## Planning and Zoning Board

**CASE NUMBER:** Z17-016 (PLN2017-00113)  
**LOCATION/ADDRESS:** 1343 South Gilbert Road.  
**GENERAL VICINITY:** Located on the east side of Gilbert Road north of Hampton Avenue.  
**REQUEST:** Site Plan Modification.  
**PURPOSE:** This request will allow for the redevelopment of a restaurant with drive-thru by replacing the existing pad building.  
**COUNCIL DISTRICT:** District 3  
**OWNER:** Amin Dhanani  
**APPLICANT:** ID Studio 4  
**STAFF PLANNER:** Wahid Alam, AICP

Proposed Site Plan

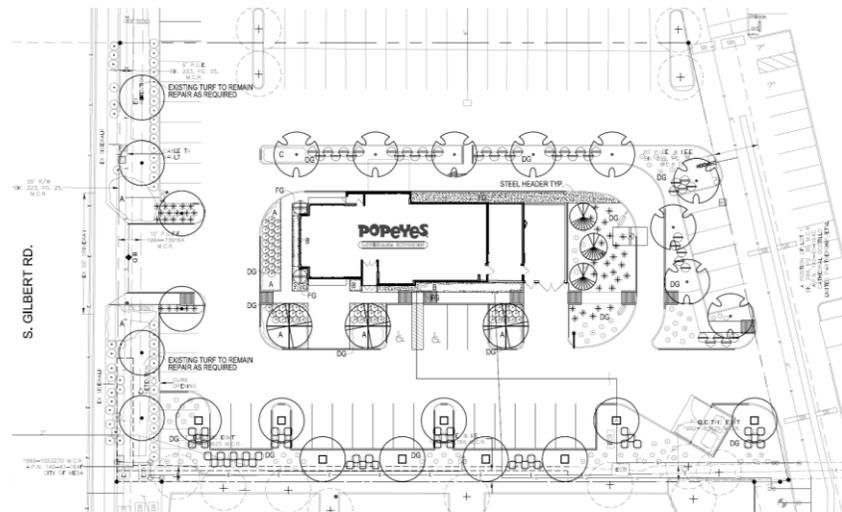
The proposed site plan maintains the existing cross access with the existing shopping center. Improved pedestrian connections are being provided from Gilbert Road through this property to the center in the back. Alternate paving material such as stamped or decorative concrete, pavers or similar finish should be provided on this site where pedestrian paths cross the drive aisles (see condition #5a).

The proposed site plan does not meet the interior parking lot landscaping requirement in the parking field north of the new building, per Section 11-33-4B. The site is over parked by 28 spaces (see analysis below) and is being completely redeveloped. Additional landscape islands consistent with code requirements need to be added to the site plan (see condition #5b).

The proposed site plan exceeds setback requirements along Gilbert Road; 18 feet is provided where only 15 feet is required. However, the landscape setback provided along the south property line is 14' where 15' is required (condition #5c). Screening of parking is also required along Gilbert Road per Section 11-30-9 H (see condition #5d). Landscaping in the foundation base and along the south side of the drive-thru lane next to the building must meet ordinance requirements (see conditions #5e and f).

The proposed site plan exceeds 125% of the minimum required spaces per Mesa Zoning Code Section 11-32-3C. Adding in landscape islands to meet the code requirements and improve the entry will reduce the number of spaces provided by seven or eight spaces. Because the site also provides parking for the larger center, the additional spaces can remain (see condition #5b).

- a) Provide an alternative paving material for crosswalks such as stamped or decorative concrete, pavers or similar finish (striping on asphalt is not acceptable).

- b) Reduce parking spaces by installing minimum 8' wide parking islands every 8 spaces, widening the existing parking lot islands per Zoning Code Section 11-33-4B, and widening the landscape islands on each side of the entry.

- c) Provide minimum 15' wide landscape yard along south property line.
  - d) Provide parking lot screening along Gilbert Road.
  - e) Design screen walls and trash enclosure compatible with building architecture in material, color and texture.

- f) Provide plant materials in the landscape area along the south side of the drive thru lane.
  - g) Provide plant material within the foundation base per Zoning Code Section 11-33-5B.
